International Code Council

**ICC 500-2020 edition
Public Input Agenda with
Committee Votes and Public Comments
based on input received
on 2014 edition of the
ICC 500 Standard**

**For February, 2020
2nd Meeting – Teleconference**

2014 ICC 500-Standard Revision Proposals – Public Comments

FIGURE 304.2(2)

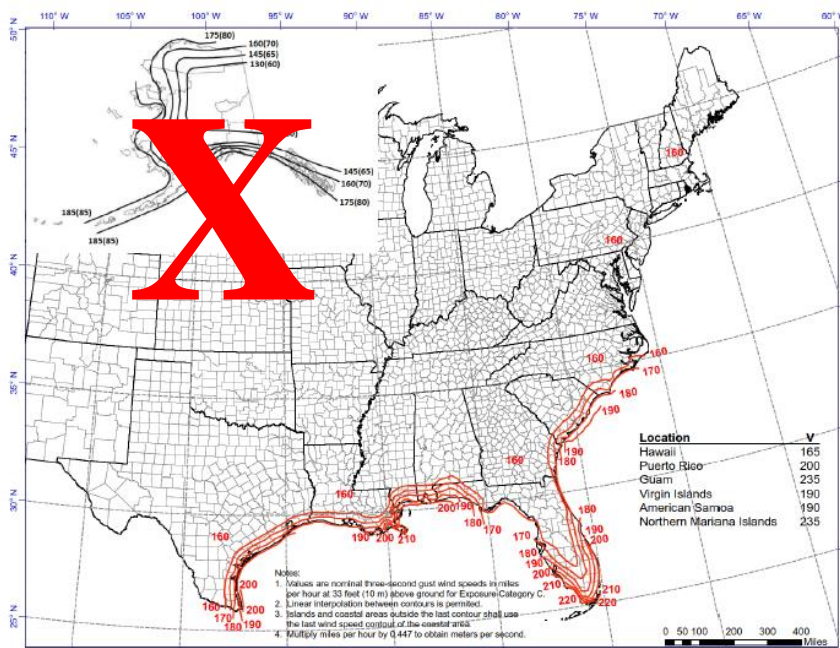
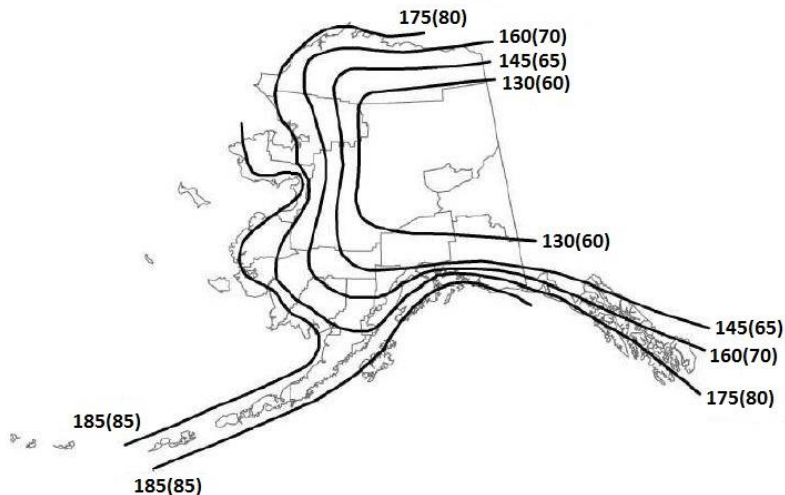
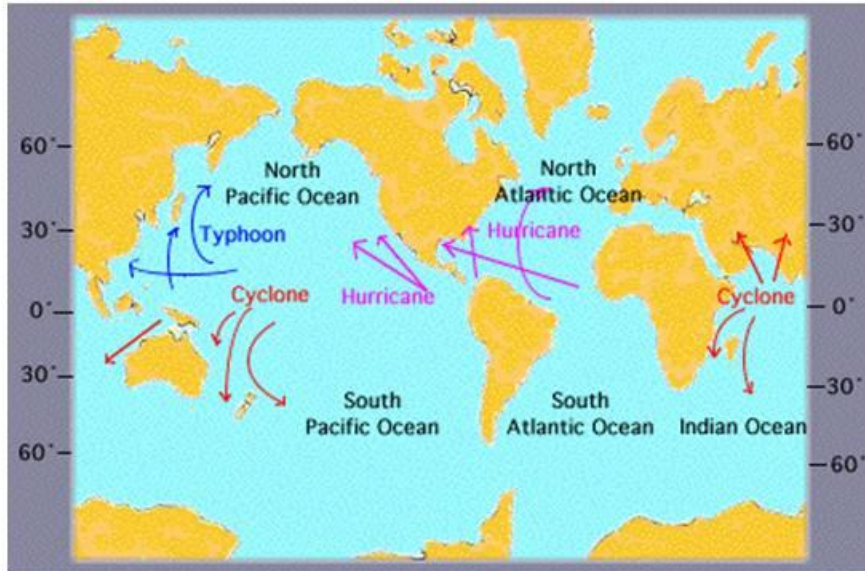
Note: Remove Alaska from current figure 304.2(2)

FIGURE 804.9.6(1) ~~SHUTTERS OR~~ OTHER IMPACT PROTECTION SYSTEMS

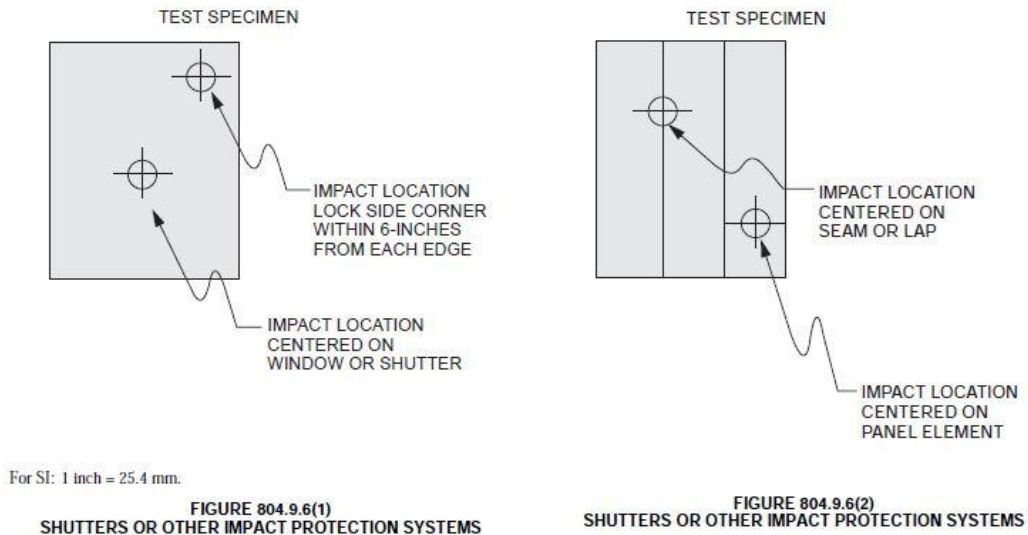
804.9.6 Other Impact-protective systems. All ~~shutter assemblies and~~ other *impact-protective systems* shall be impacted in the center of the closed opening, and at one interface corner as detailed in Figure 804.9.6(1). Panels and interface joints shall be impacted as shown in Figure 804.9.6(2). Interface hinge joints and primary latches, where present, shall be impacted as shown in Figure 804.9.5(2) on an additional specimen. All ~~shutter assemblies and~~ impact protection systems that include swinging door assemblies with latching hardware shall be tested in accordance with Section 804.9.5.

FIGURE 804.9.5(3)
ROLLING DOOR ASSEMBLIES

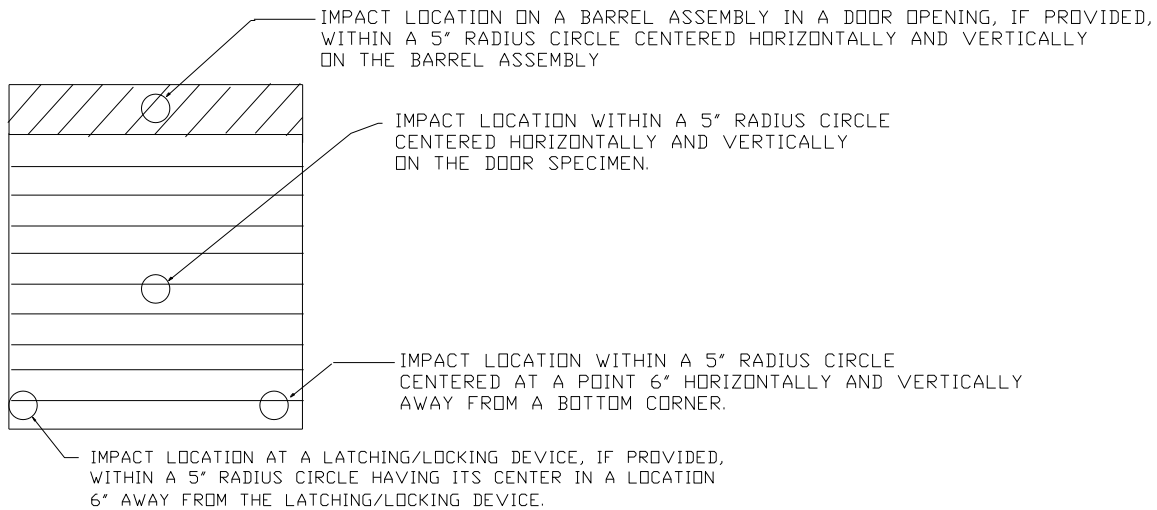
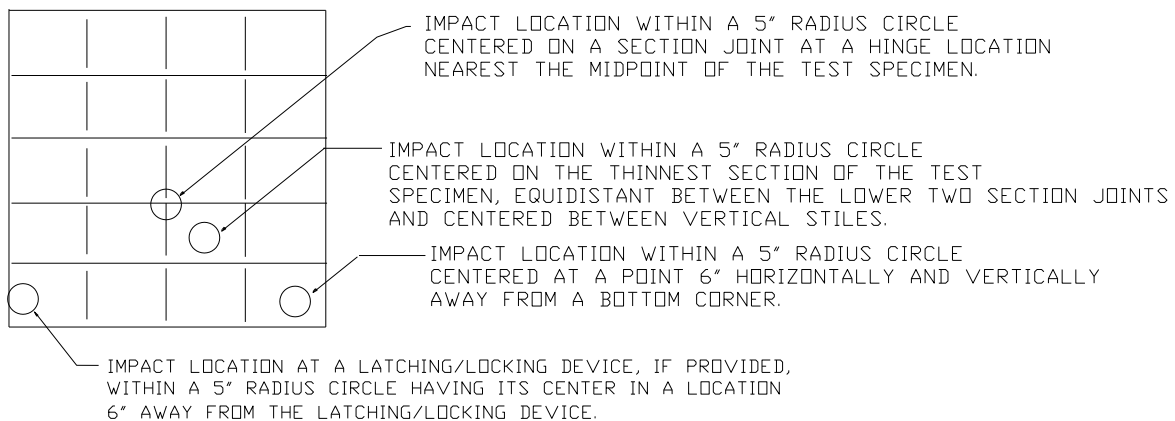
For rolling door assemblies, the door shall receive two impacts as shown in Figure 804.9.5(3) plus an additional impact on a latching/locking device if provided, plus an additional impact on a barrel assembly if mounted in the door opening.

For sectional door assemblies, the door shall receive three impacts as shown in Figure 804.9.5(4) plus an additional impact on a latching/locking device if provided.

Reason: Clarify application of door impact provisions with respect to testing of rolling and sectional doors

FIGURE 804.9.5.2
ROLLING DOOR ASSEMBLIES

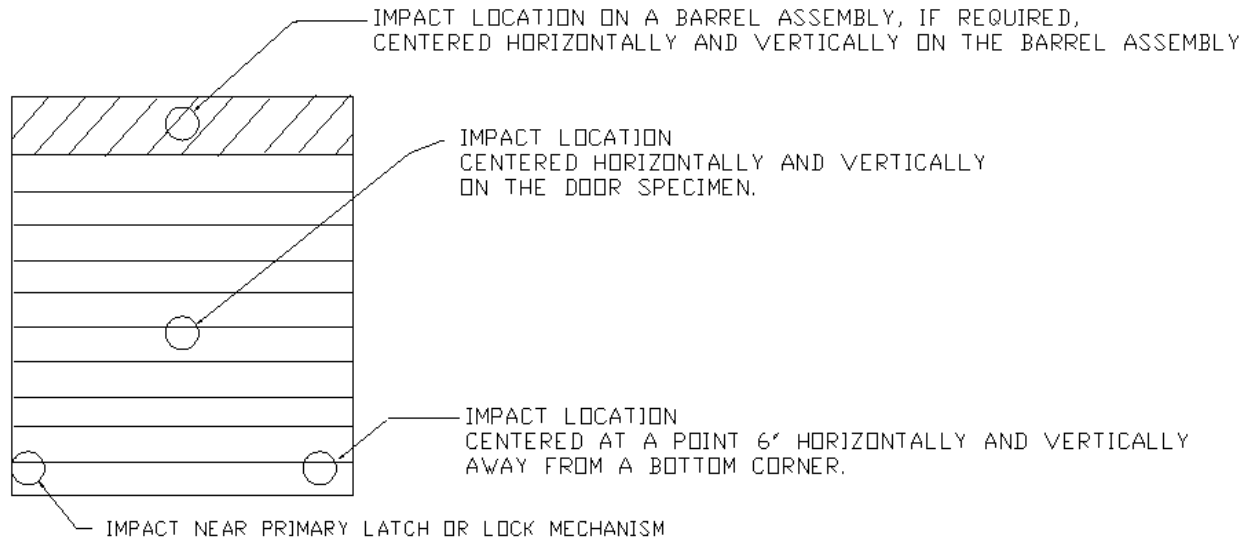
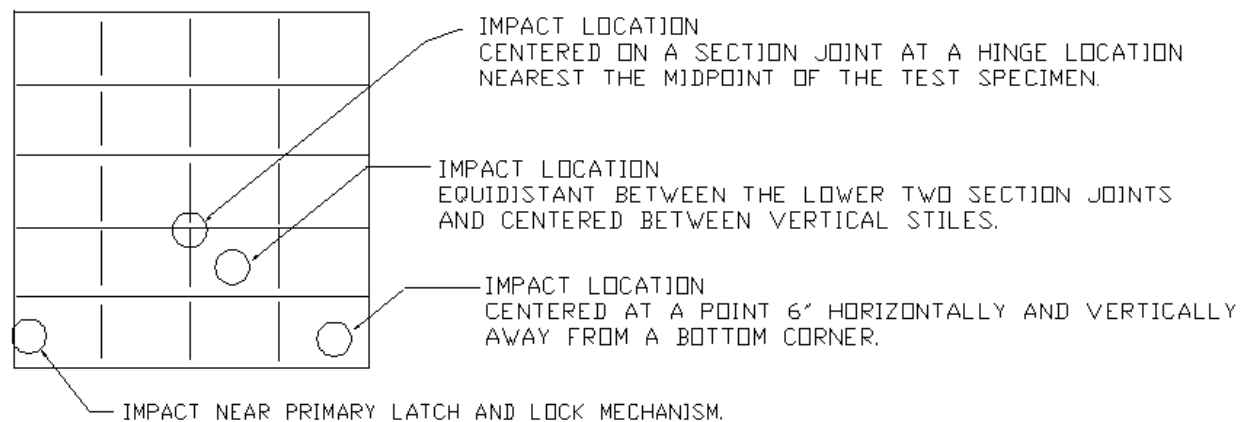
Exception: The barrel assembly is not subject to the additional impact where the entire barrel assembly is protected by the shelter envelope.

804.9.5.3 Sectional door assemblies. For sectional door assemblies, the door shall be impacted at a sectional joint nearing to the center of the door, within the lower two section joints and centered between two vertical stiles, at one bottom corner, and within 6 inches (152 mm) of the primary latches or operators as shown in Figure 804.9.5.3.

FIGURE 804.9.5(1) – SINGLE DOOR TEST SPECIMEN

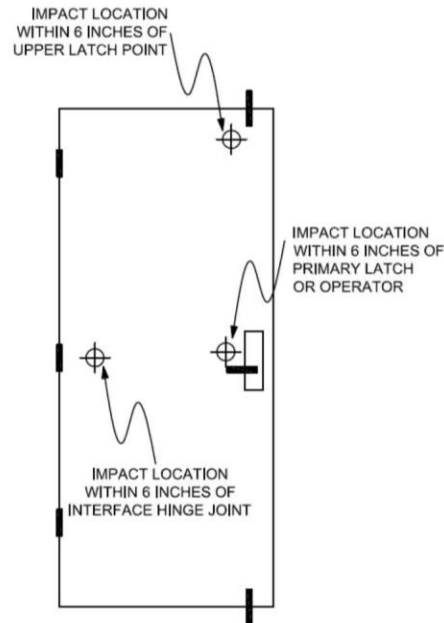
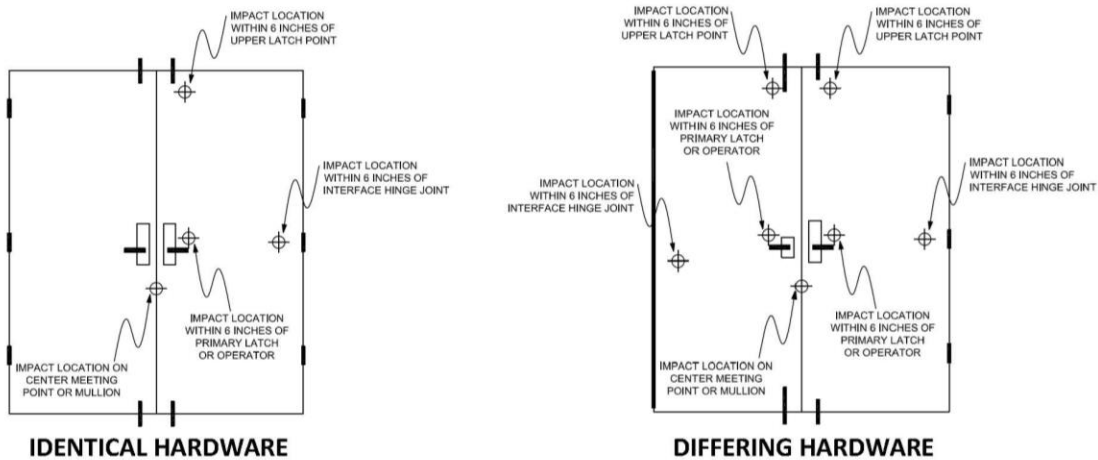
Figure 804.9.5(1) [Single door assemblies](#) ~~Doors and other egress/entry systems~~

Figure 804.9.5(2) [Double door assemblies](#) ~~Doors and other egress/entry systems~~

**FIGURE 804.9.7.2
DOORS SUBJECT TO REBOUND IMPACT**

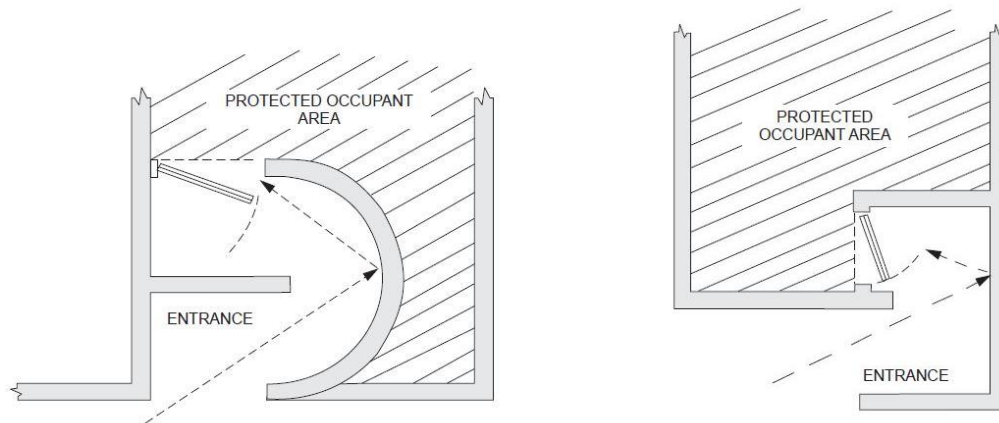
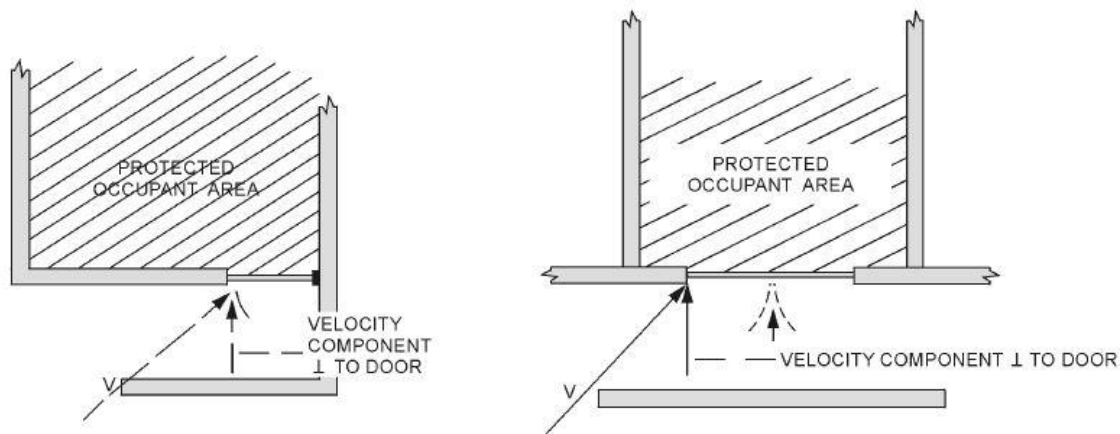
804.9.7.2 Door subject to rebound impact. Where the alcove or baffled entry system prevents a first impact of the design missile on the door but the door is subject to a rebounded impact of the design missile after it has impacted one surface meeting the requirements of Section 306.2 possible (~~see [as detailed in](#) Figure 804.9.7.2~~), then a door assembly shall meet the wind load requirements of Section 304 and the debris impact requirements of Section 305 except that the missile shall be, at a minimum, a 9-pound sawn lumber 2 by 4 traveling at 50 feet per second (15.2 m/s). Entry systems having doors that are protected from the initial and first rebounded impacts of debris shall comply with the requirements of Section 804.9.7.1.

804.9.7.3 Door subject to first impact. If a first-strike angle missile impact on the door is possible (~~see as detailed in~~ [Figure 804.9.7.3](#)), then the door is deemed suitable if the door assembly meets the wind load requirements of Section 304 and the door assembly meets one of the following debris impact criteria:

Reason: The way figures are referenced is not consistent and does not make the figure part of the requirement. Using “as detailed in” or “as shown in” would be consistent with the figure references of impact location in 804.9. In Items 1, 2 and 3 of Section 804.9.7, “Examples of this type of system are shown in Figure...” is not needed. As written it is editorials information, not a requirement; and the figures are referenced in each of the referenced sections.
